OGDEN CITY PLANNING COMMISSION

June 4, 2025

Agenda Name: Preliminary subdivision approval of the 605 Jackson/Lewis Ridge Subdivision consisting of twenty-nine lots for a new single-family home development at approx. 605 North Jackson Avenue

PLAN CORRECTIONS REPORT PREDEV000363-2025 FOR OGDEN CITY

UPDATED Subdivision Plat

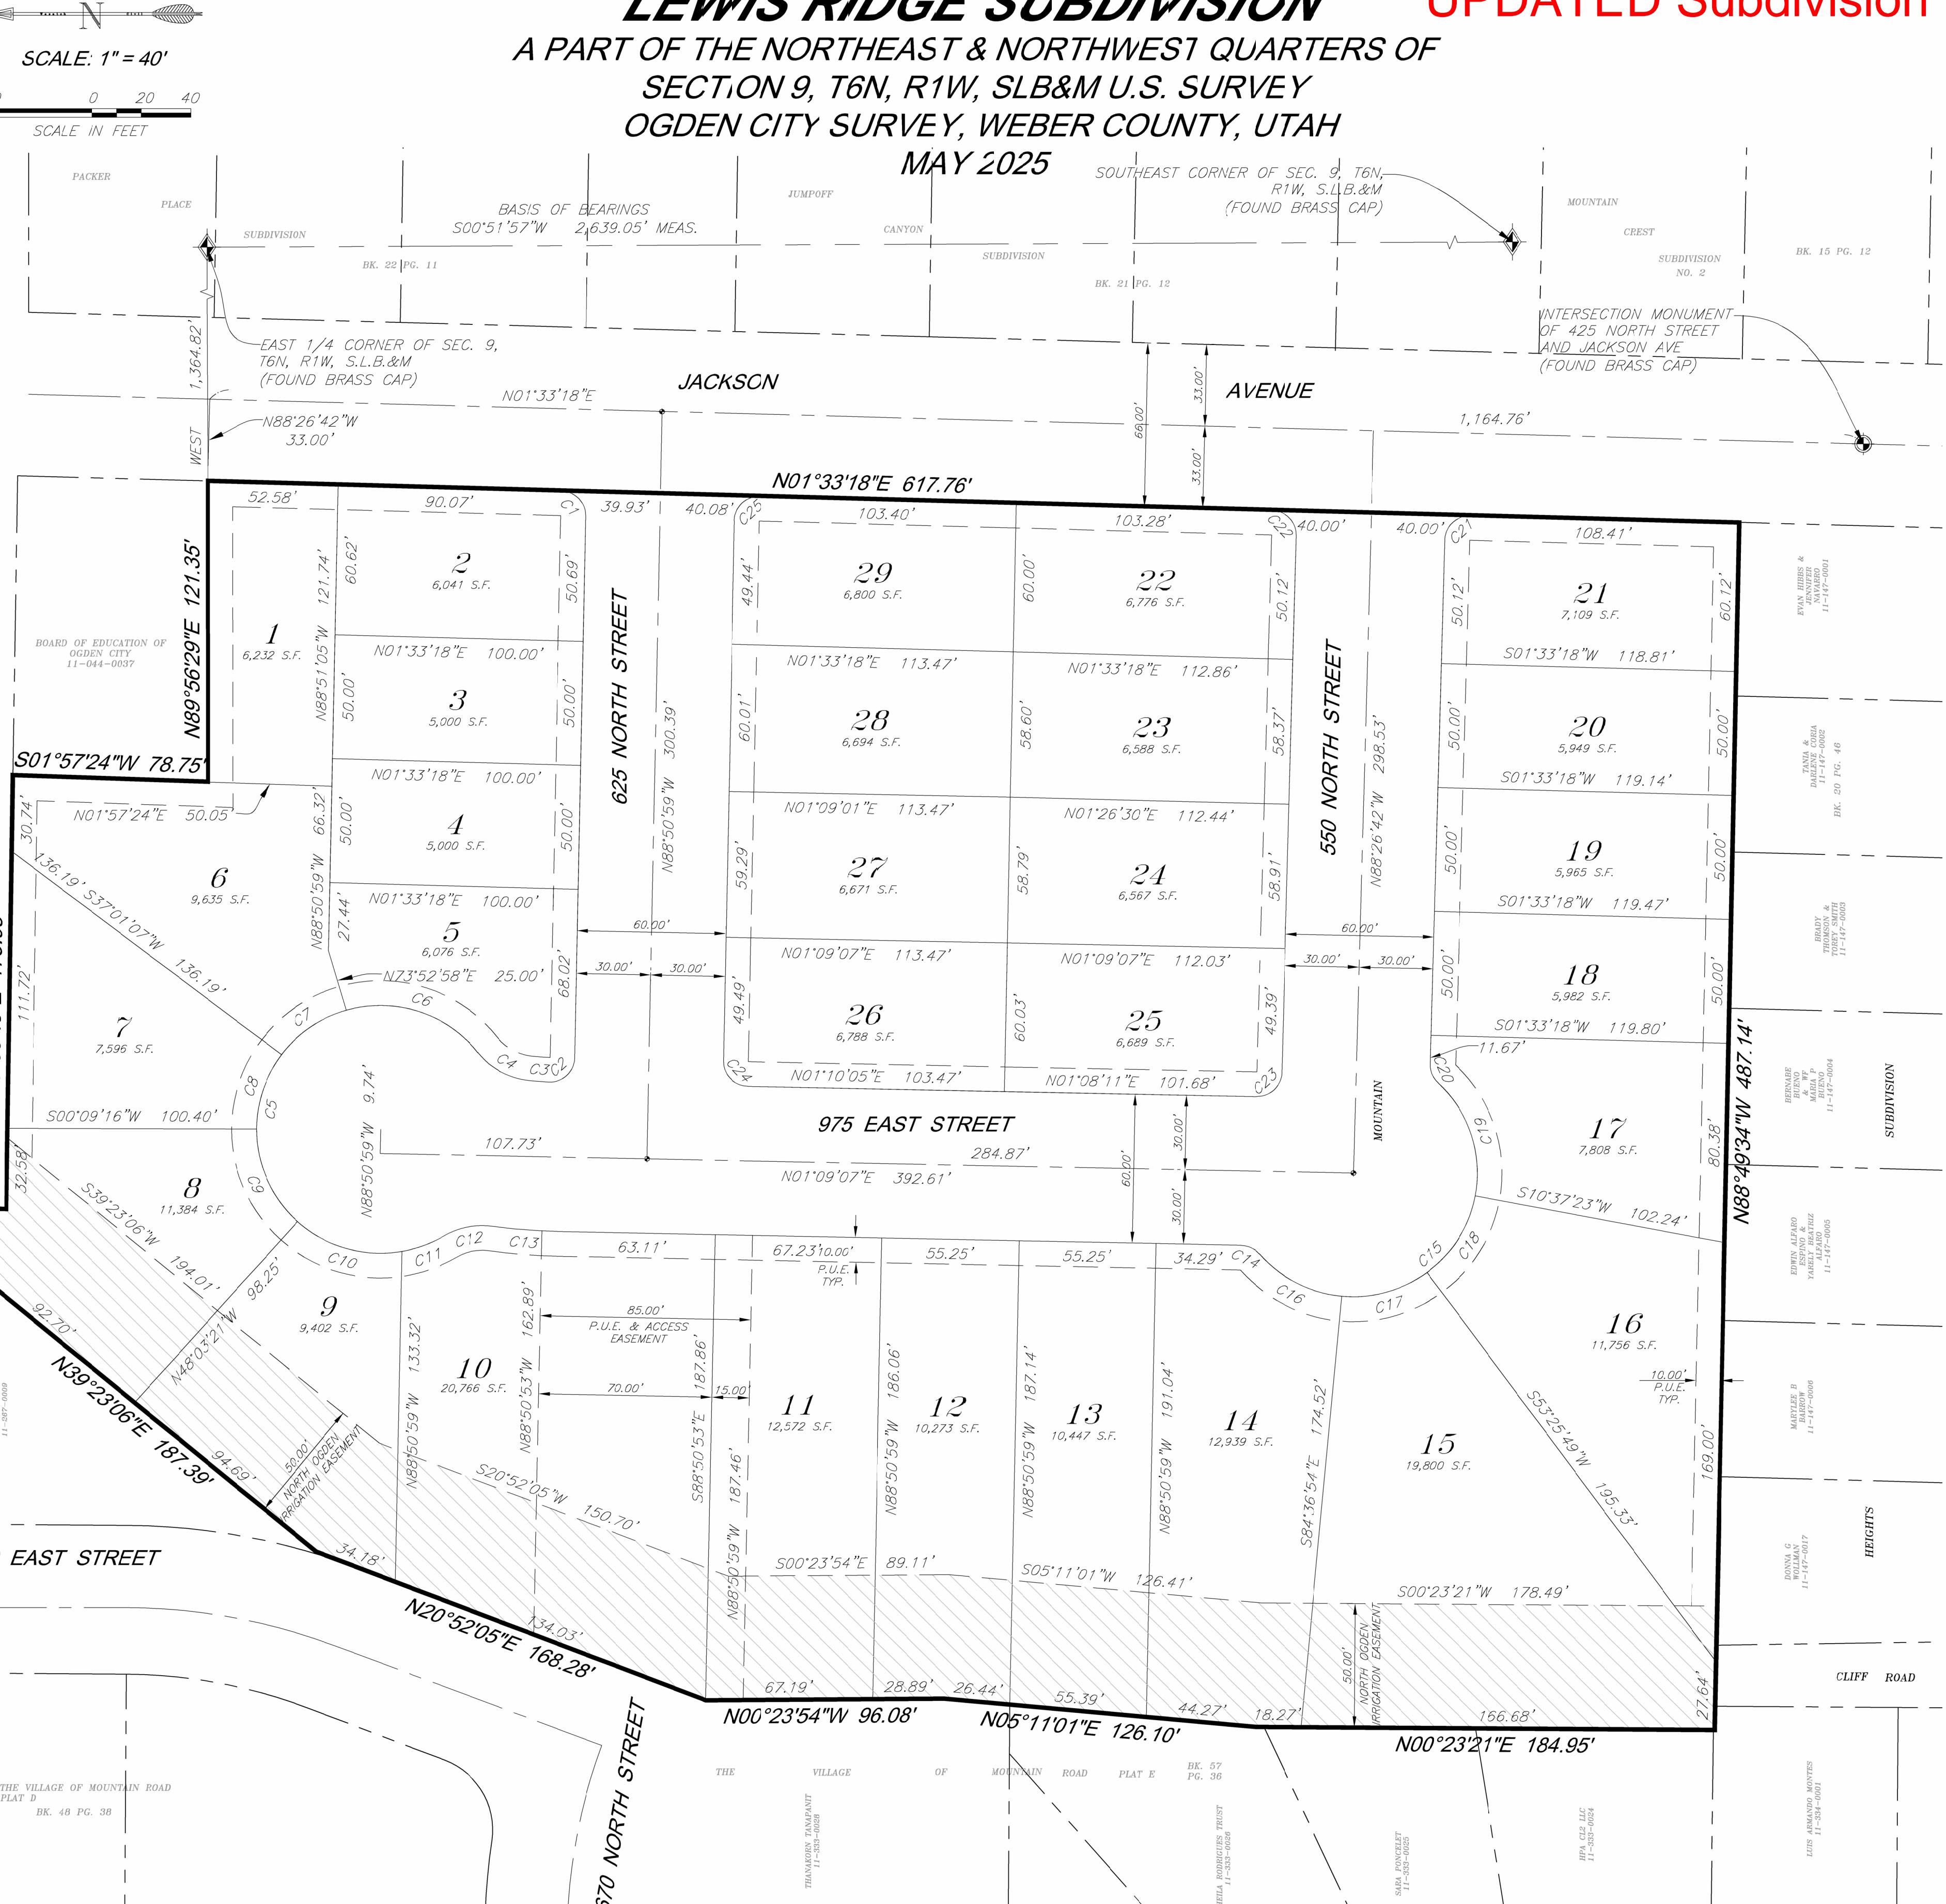
The plat needs a valid surveyor's stamp, not an engineer's stamp. (Signature and date across the seal.)

There must be a 10' MUE along all public ROWs and a 5' MUE along all other property lines.
Change any PUE (Public Utility Easement) labels to MUE (Municipal Utility Easement).

Provide information about parcel A and the intent for it. I know the detention pond will be on it, but will some sort of HOA own/maintain it? Is it intended to dedicate that parcel to the city for maintenance? Will easements be needed for that parcel? Etc.

Corrective Action: The lots in the subdivision must meet the minimum lot width requirements established by the R-1-5 zone. The subdivision plat will need to be modified to show the minimum 60' wide corner lot widths of the proposed lots: 21, 22, 25, 26, and 29 will be met. Additionally, the plat will need to be modified to show that 50' lot widths will be met at the required front yard setbacks, which is 25'. Lots 6 and 7 will need to be modified to meet this minimum lot width requirement.

SHEET:
2
OF 3 SHEETS

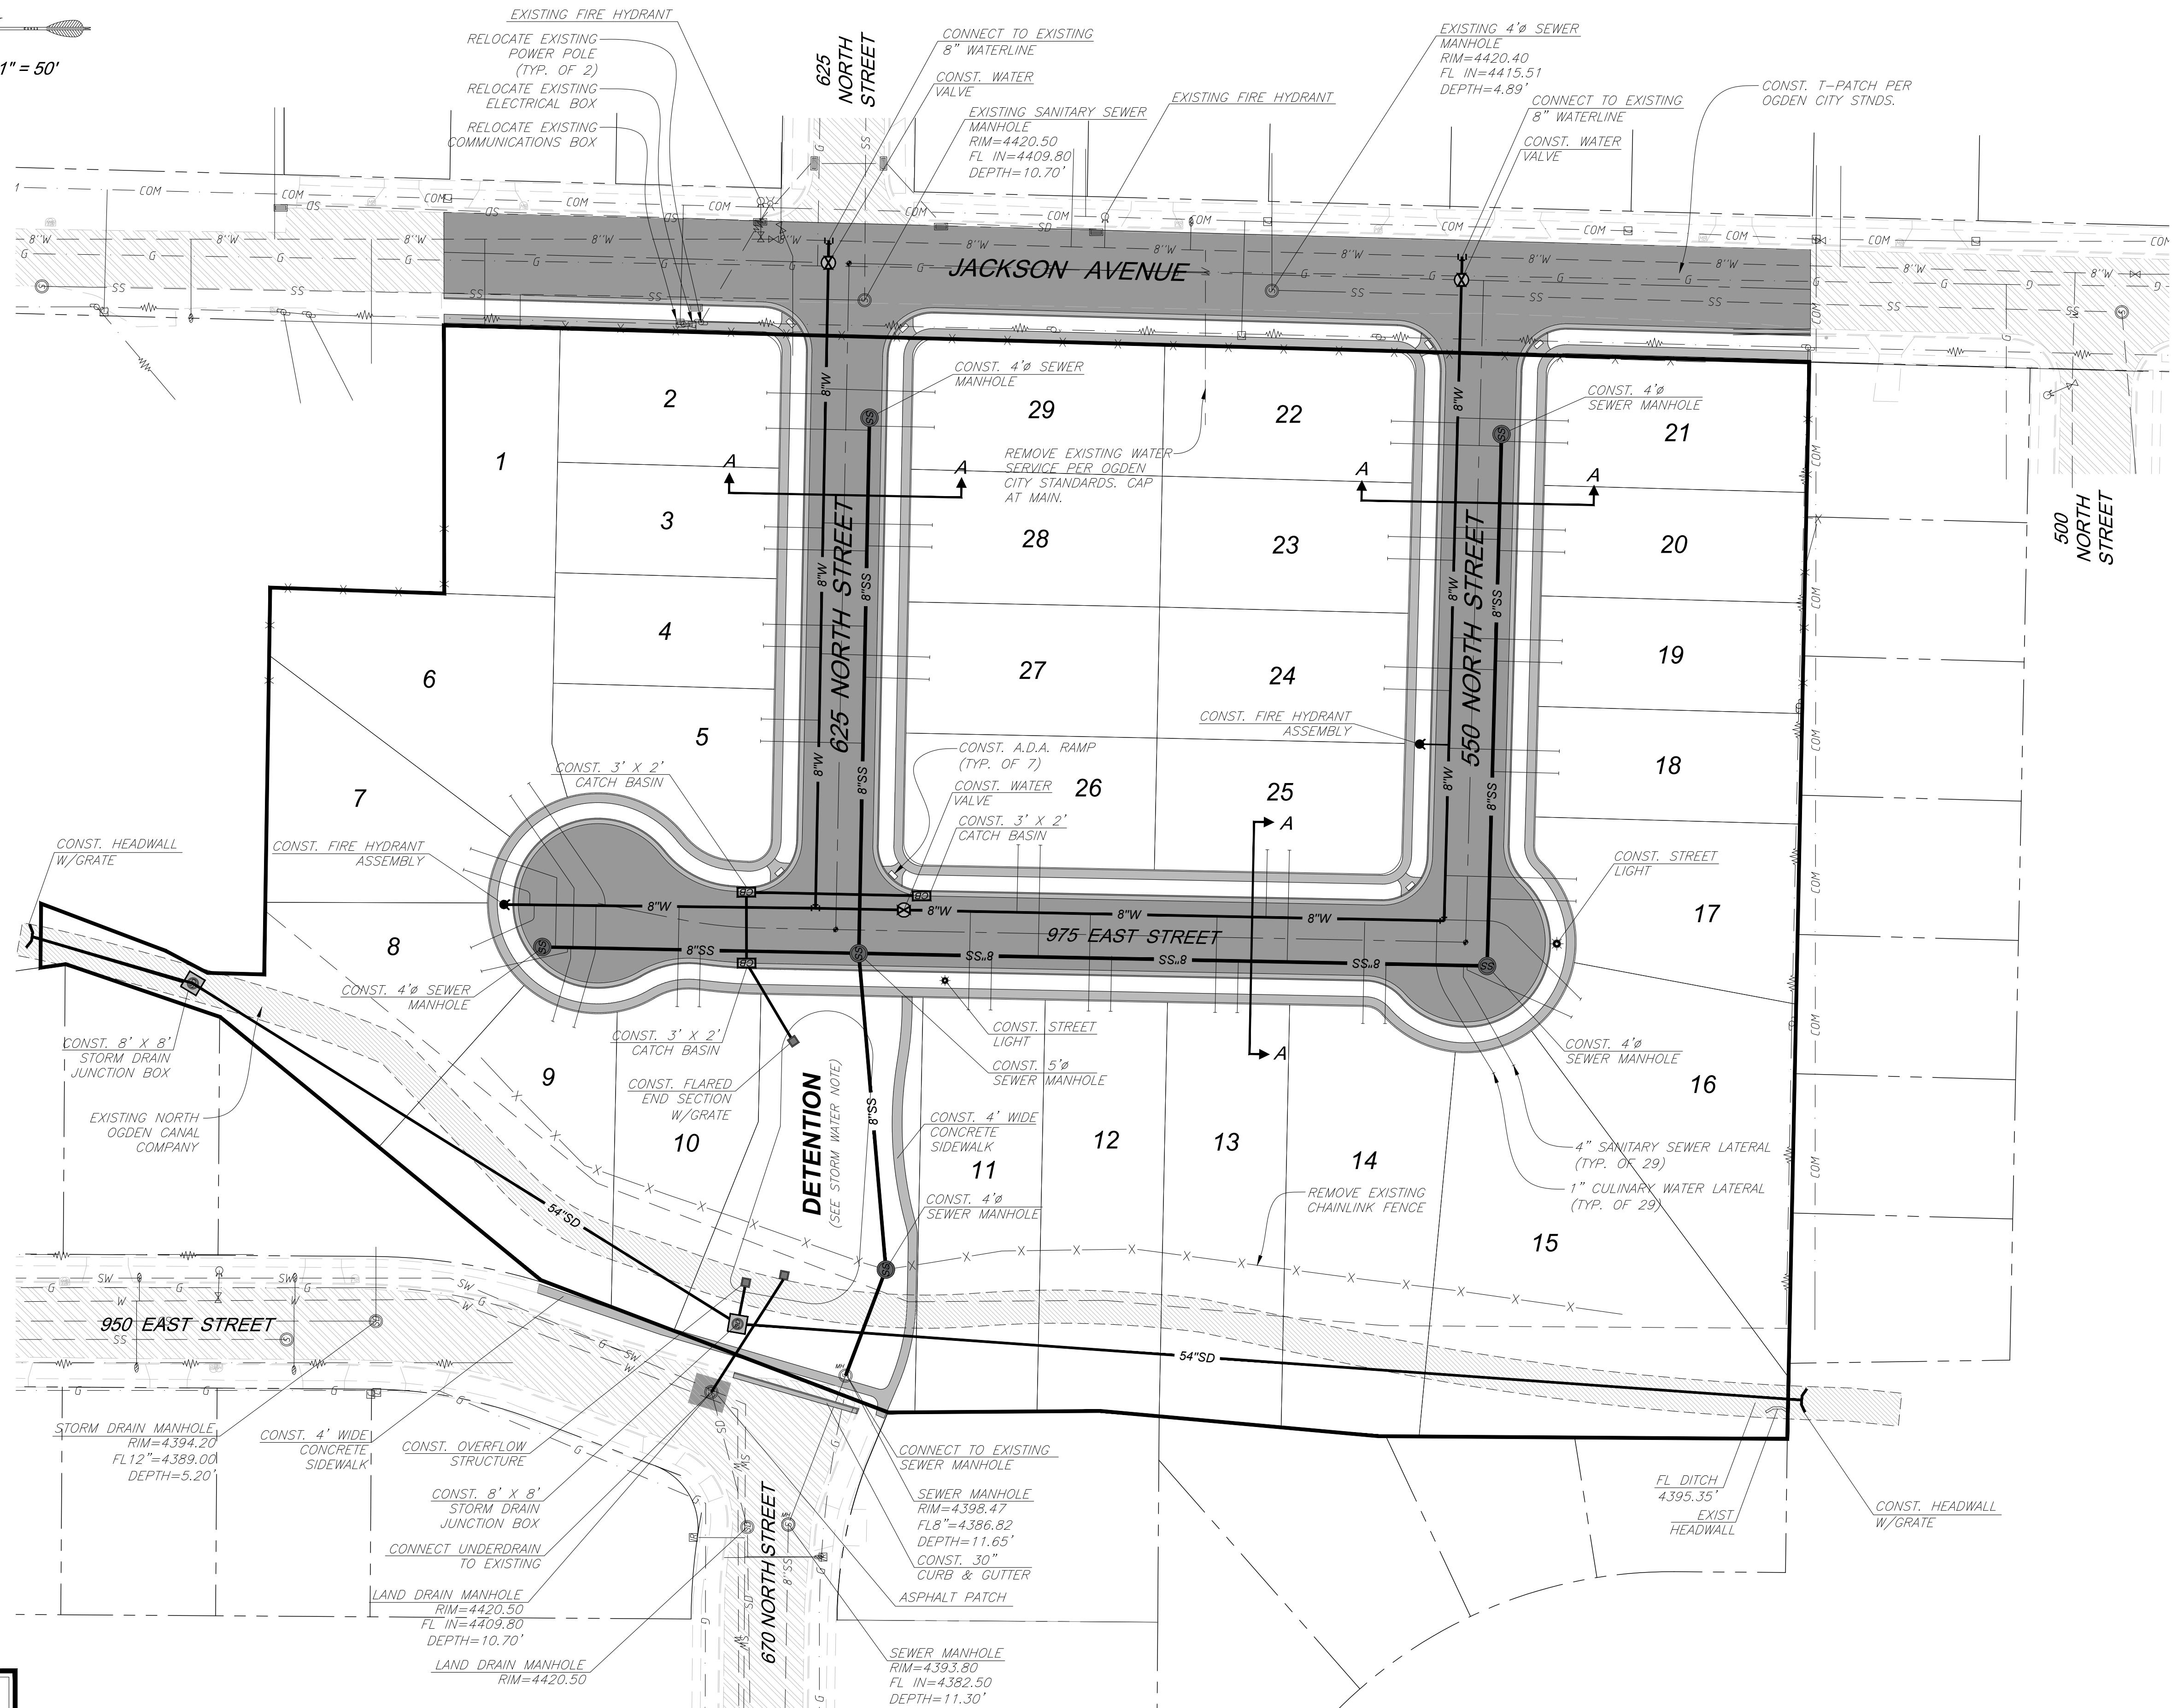
I think the wrong scale is indicated on the plans. The plans show a 1"= 50' but that makes a bunch of measurements off. If I swap to a 1" = 40' scale then it seems to solve that problem.

The curb/gutter will need to be placed per Ogden City Standard. The placement is based on the ROW width/ road classification. The new road's curb will need to be adjusted to match the requirement for its ROW width.
Reference the Ogden City Road Section Standard Detail for placement.
(Might be due to an incorrect scale)

The curb on Jackson Ave will need to match the width of the existing curb to the south.
The plan's scale has the lip to lip width at approximately 45 feet, but google earth measurement has the existing lip to lip at about 36 feet.
(Might be due to an incorrect scale)

The new sidewalk will need to be 4 feet wide, not 5 feet.
The sidewalk placement/park strip width is dependent on the classification of the road.
Reference the Ogden City Road Section Standard Detail for placement.
(Might be due to an incorrect scale)

The cul-de-sac is not correct. Refer to the Ogden City Standard detail for cul-de-sacs.
The sidewalk will need to be 6' wide directly behind the curb.
The curb in the cul-de-sac will need to be type F. Indicate the curb transition from type A to Type F. The transition must be 10 feet long.

The knuckle will need to follow the same standards as a cul-de-sac. (6' wide sidewalk directly behind curb, type F curb, 10-foot curb transitions.)

The cul-de-sac radius is incorrect. With a 1:50 scale it is too big, and with a 1:40 scale it is too small.
(This applies to the knuckle too.)

The intersection radiiuses are incorrect. (Might be due to an incorrect scale)
